# HISTORIC AND DESIGN REVIEW COMMISSION

**HDRC CASE NO:** 2024-382  
**ADDRESS:** 622 CEDAR ST  
**LEGAL DESCRIPTION:** NCB 2912 BLK 1 LOT S 25 FT OF 6 & N 40 FT OF 7  
**ZONING:** RM-4, H  
**CITY COUNCIL DIST.:** 1  
**DISTRICT:** King William Historic District  
**APPLICANT:** RICARDO RUIZ  
**OWNER:** RICARDO RUIZ/RUIZ RICARDO D & MAUREEN L  
**TYPE OF WORK:** Front porch screen installation  
**APPLICATION RECEIVED:** November 08, 2024  
**60-DAY REVIEW:** January 7, 2025  
**CASE MANAGER:** Bryan Morales

The applicant is requesting a Certificate of Appropriateness for approval to enclose an existing front porch with permeable aluminum screening.

South Elevation

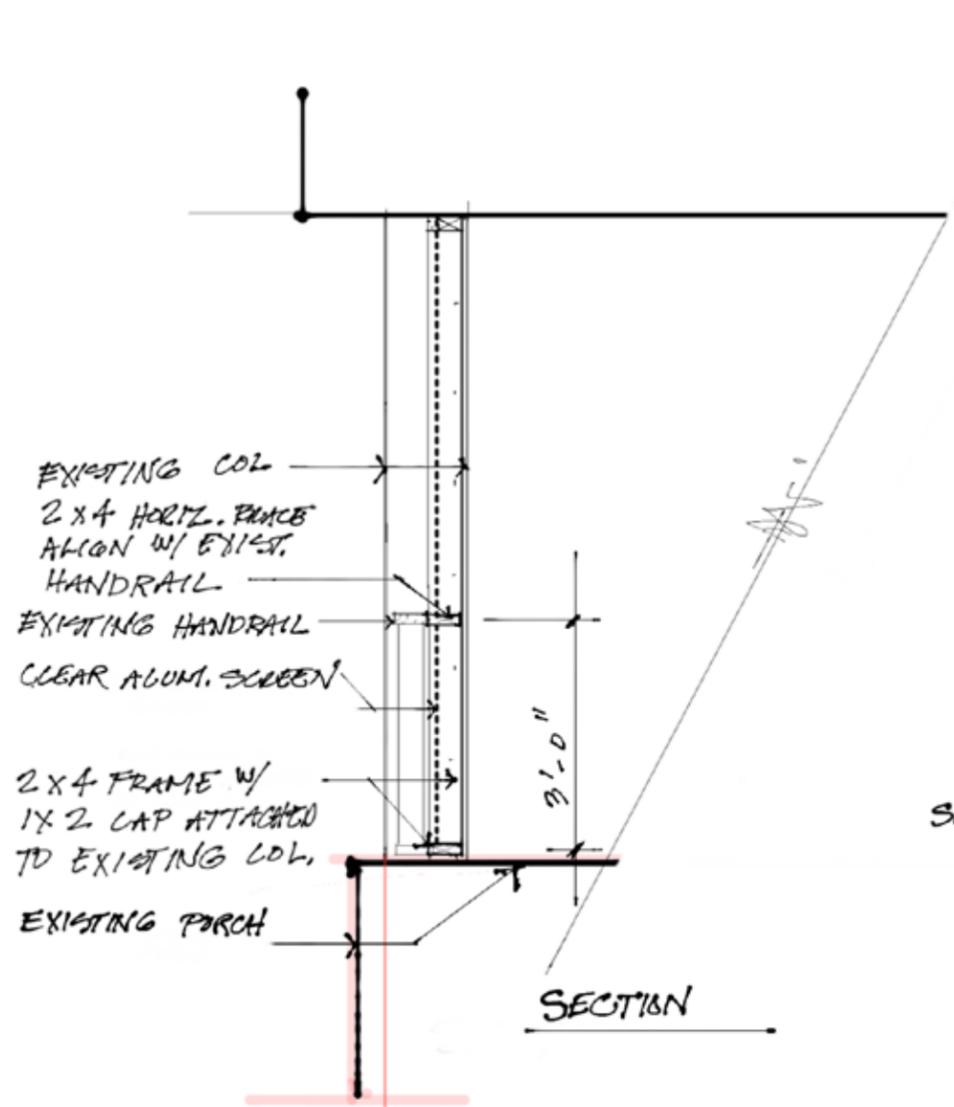
- b. **PORCH SCREENING** – The applicant has proposed to install aluminum screening to screen the front porch in its entirety. The Historic Design Guidelines for Exterior Maintenance and Alterations 7.B.i. notes that applicant should refrain from enclosing front porches. The Guidelines additionally note that approved screen panels should be simple in design as to not change the character of the structure or historic fabric. The applicant has noted aluminum screening that will result in a high level of transparency. The screening panels will be installed behind the face of the columns and will be framed in wood. Staff finds this request to be appropriate and consistent with the Guidelines.

Staff recommends approval of the request as submitted based on the findings.
